SUBJECT: STANDBY LIQUID CONTROL SYSTEM (TAC NO. 72630)

RE: LIMERICK GENERATING STATION, UNIT 1

Amendment No. 22
License No. NPF-39

SAFETY EVALUATION BY THE OFFICE OF NUCLEAR REACTOR REGULATION
SUPPORTING AMENDMENT NO. 22 TO FACILITY OPERATING LICENSE NO. NPF-39

FIGURE 3.1.5-1

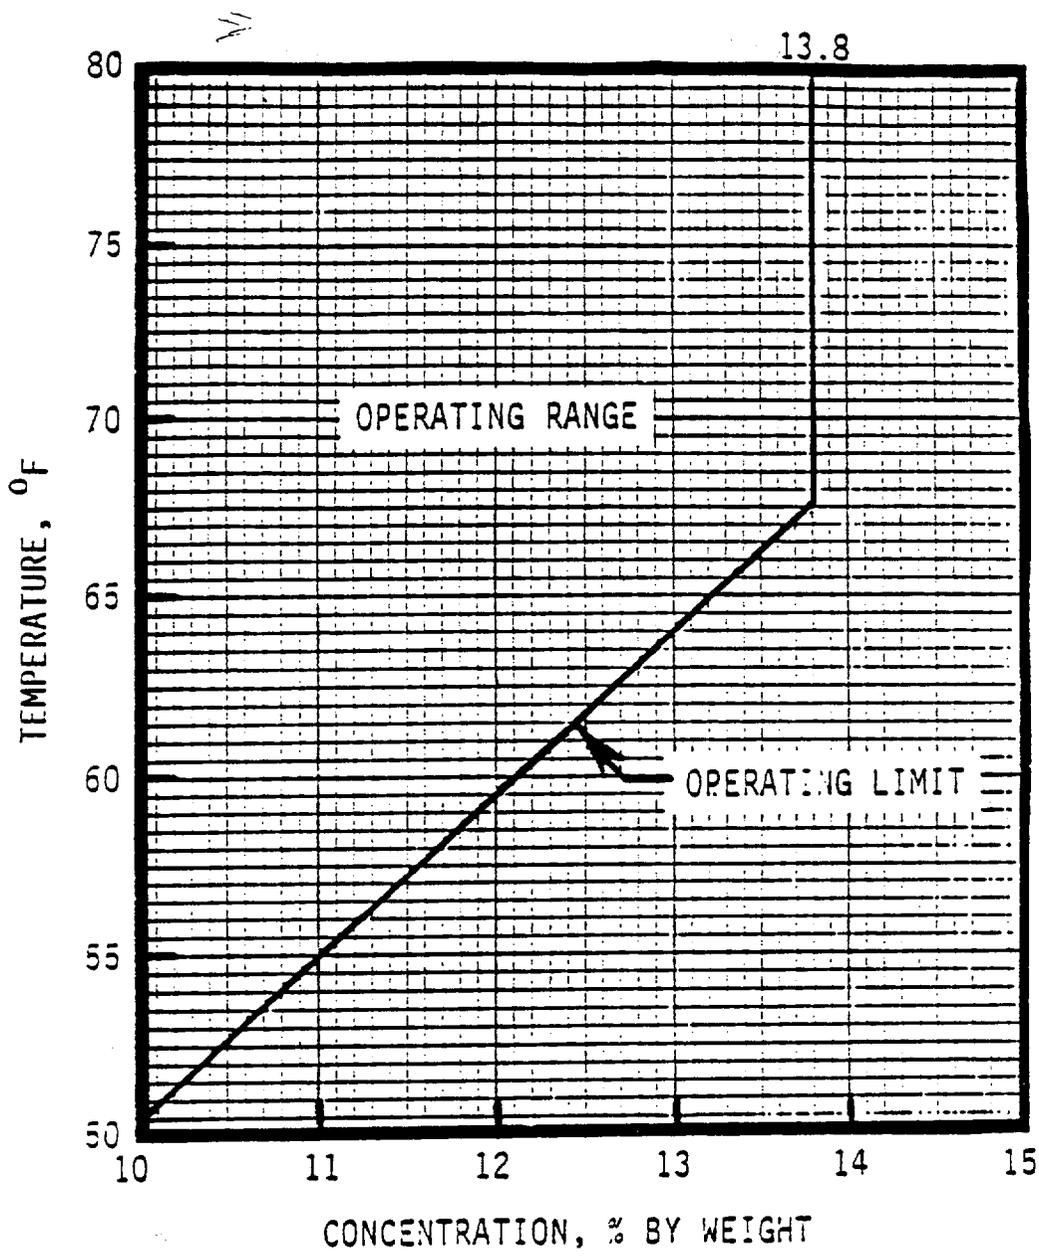
In addition, the proposed changes revise Figure 3.1.5-1 to provide a more conservative operating limit of sodium pentaborate temperature versus concentration. This new limit will provide for consistency with FSAR Figure 9.3-7 which properly depicts the operating limit.

SR 4.1.5.a.2, which currently requires the volume limits of Figure 3.1.5-2 to be met, is revised to require only the minimum volume (see above). The maximum concentration limit of 13.8 percent is retained in the revised Figure 3.1.5-1. The minimum sodium pentaborate solution concentration will be governed by the equivalency equation of SR 4.1.5.b.2 and will be a function of SLCS two pump flow rate. The "margin" and "overflow volumes" of the current Figure 3.1.5-2 are not significant solution parameters and therefore can be deleted. These values were provided for information only, and are available in the appropriate Surveillance Tests. Operation with a solution volume up to the tank overflow nozzle is acceptable from a safety perspective as long as the chemistry requirements of the solution are met. The impact on
